MARTIN COUNTY

Engineering Department

Re: North River Shores Dredge Request

North River Shores
Dredge Request Locations

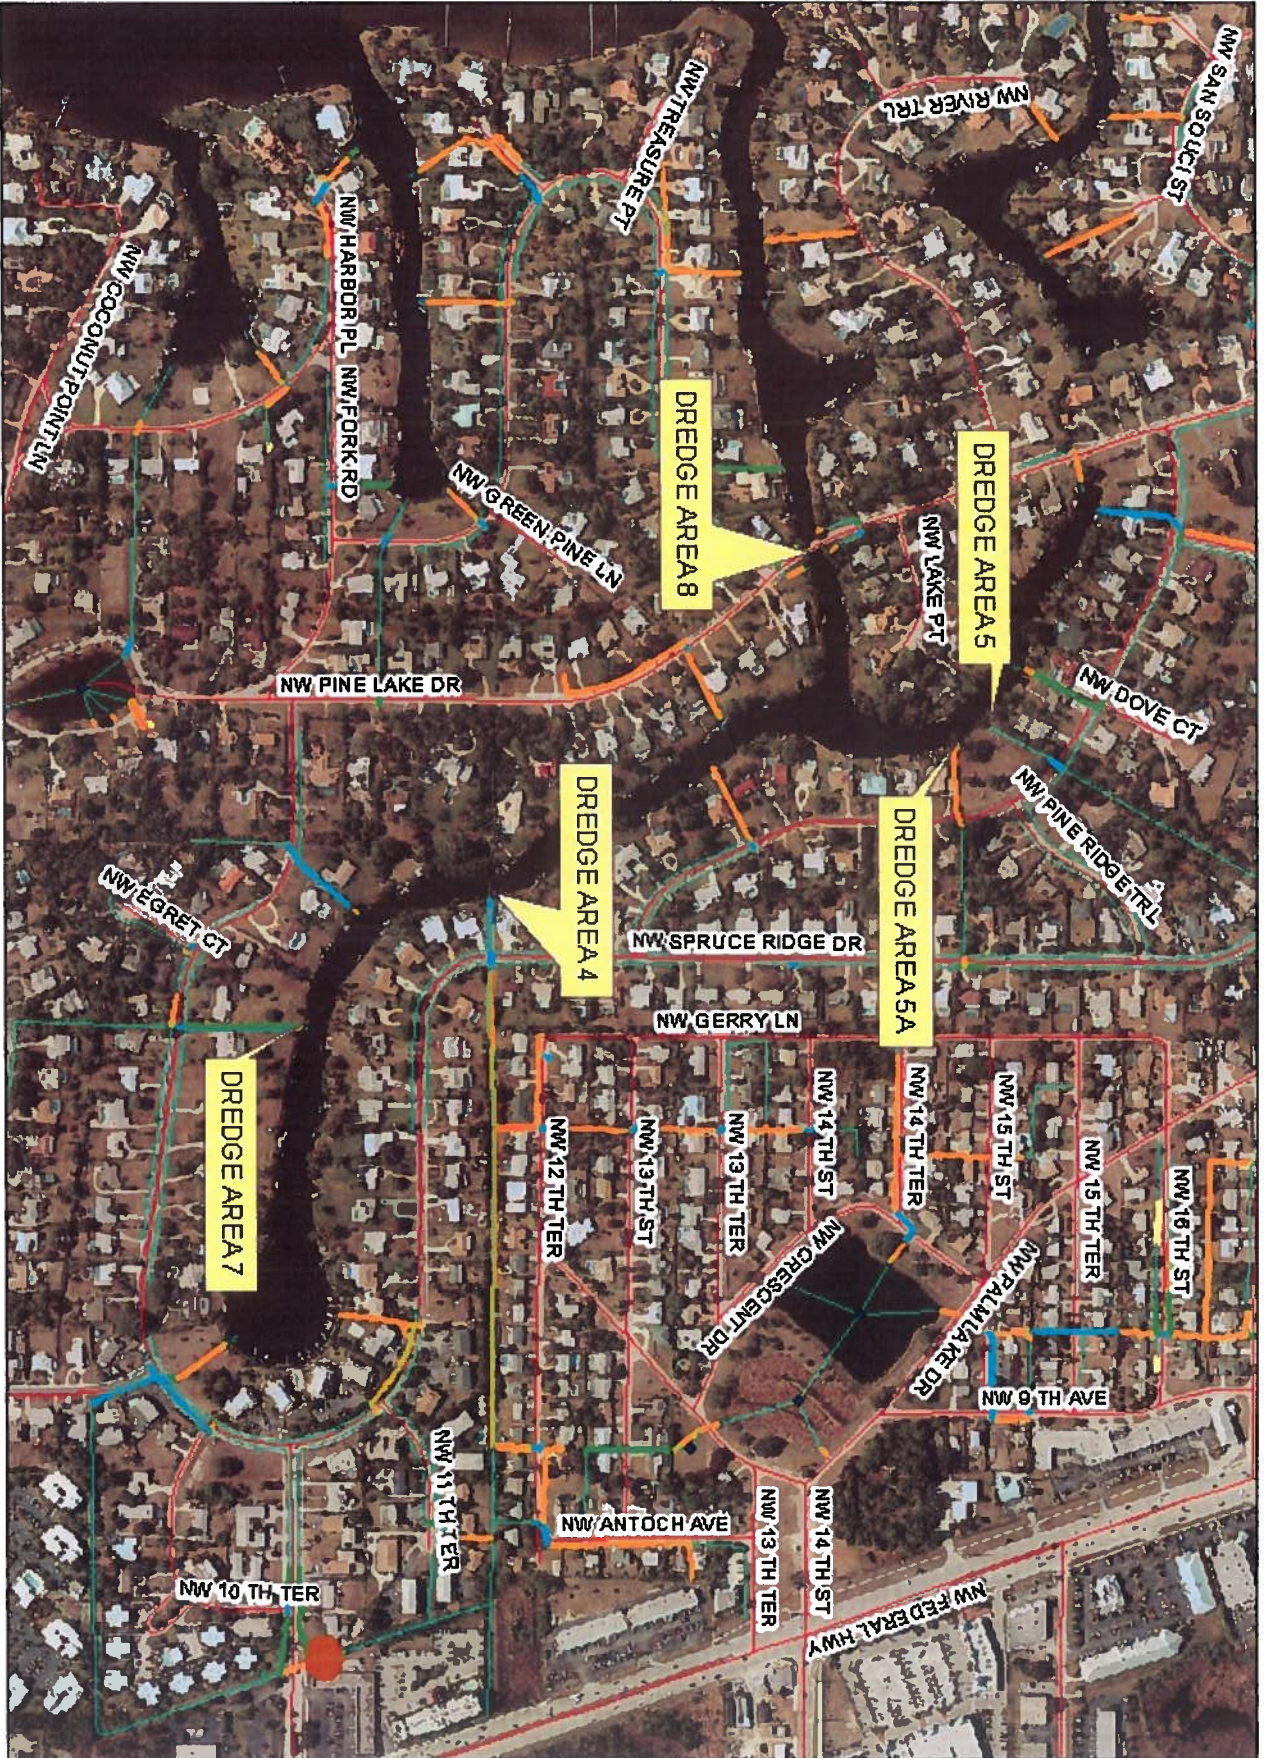
Dredge Area 4: This location is in the canal north of 1194 NW Spruce Ridge Drive. There are two 36" diameter pipes that outfall in this location. There is a large baffle box upstream of this outfall that captures sediments before they can be released into the canal. The sediment in the channel appears to be contributed by the failing adjacent seawall and the improperly tied together seawalls north of the pipes. It also appears that a majority of this sediment is displaced from the lake bottom at the pipe outlets rather than newly deposited material. There is no obvious failure related to the drainage system, and as such the County cannot participate in the proposed dredging at this location.

Dredge Area 5: This dredge location is adjacent to the community park south of 1440 NW Lakeside Trail at the outlet of the Vista Del Lago ditch. There is a concrete weir at the outfall to provide water quality. While there is a control in place to minimize sediment, the weir did fail during Tropical Storm Fay and a small amount of sediment was released when the weir was breached. There is no seawall or bank stabilization present in the park, which is a contributing sediment transport source. We recommend that the HOA consider properly stabilizing this bank. The County will entertain working with the HOA for sediment removal at this location, and will rework the ditch upstream of the weir to provide more detention volume and storage for sediments. Further, we will revise our maintenance program in the Vista Del Lago ditch to reduce the use of chemical weed control.

Dredge Area 5A: This dredge area is located in the same park as Dredge area 5, but is along the south side of the park. A 30" HDPE pipe outfalls into the lake at this location through a stacked rip rap wall. The pipe is connected to a baffle box (sediment trap) at the roadside. There is a group of mature mangroves in the lake at this location, which is indicative of a shallow soil base in the lake. The prop roots from the mangroves retain and accumulate sediment, so it is likely that sediments in the lake will continue to build in this location going forward. The roots from the mangroves have grown into the rip rap wall, and have created voids that have allowed sediment to pass

through the wall. Subsequent to our onsite meeting, County staff met with Department of Environmental Protection Submerged Lands staff onsite to discuss trimming of the prop roots in this location. We were given approval from DEP to trim the mangrove and rework the rip rap wall to eliminate future sedimentation from this source. Similar to Dredge area 5, we recommend that the HOA consider proper stabilization of the bank to reduce erosion and sedimentation from the park. The County will entertain working with the HOA for sediment removal at this location, but stress the need to be conservative during the dredge process to protect the mangroves in this location.

Dredge Area 7: This dredge area is located between 794 and 804 NW Spruce Ridge Drive. There are two 30" diameter corrugated metal pipes that outfall in this location. The exposed portions of the pipes are degraded at the lake, but were internally inspected using CCTV technology and found to be sound. There are, however, two significant sediment sources present in this location. The seawall has failed at 794 NW Spruce Ridge Drive, with many yards of sediment missing from behind the wall. Additionally, the CCTV inspection revealed that there is an illicit connection in the easternmost pipe adjacent to 804 NW Spruce Ridge Drive that is poorly sealed up. It appears that the property owner may have connected their pool drain directly to the pipe, and soil is being lost through the hole that was made in the drainage pipe. The illicit connection should be removed and the pipe repaired by the homeowner. The County will not participate in the dredge cost share in this location.

Dredge Area 8: This dredge area is located at all four corners of the NW Pine Lake Drive bridge embankment. There is evidence of erosion on the northeast and southwest corners of the bridge, and a recently installed seawall is evident at one of the adjacent residences (1528 NW Lake Pt) which is indicative of a past sedimentation source. The County will entertain working with the HOA for sediment removal at this location, and will sod the disturbed area on the northeast corner of the bridge embankment to reduce future sedimentation.

In summary, we have identified three proposed dredge areas (5, 5A and 8) that may include a percentage of sediments generated from a documented failure of the County stormwater system. The remaining two areas (4 and 7) exhibited sediment sources unrelated to a failure of the County's drainage system. As such, the County would like to meet with you to discuss the mechanism for cooperating with your project for areas that you identified as 5, 5A and 8 only.
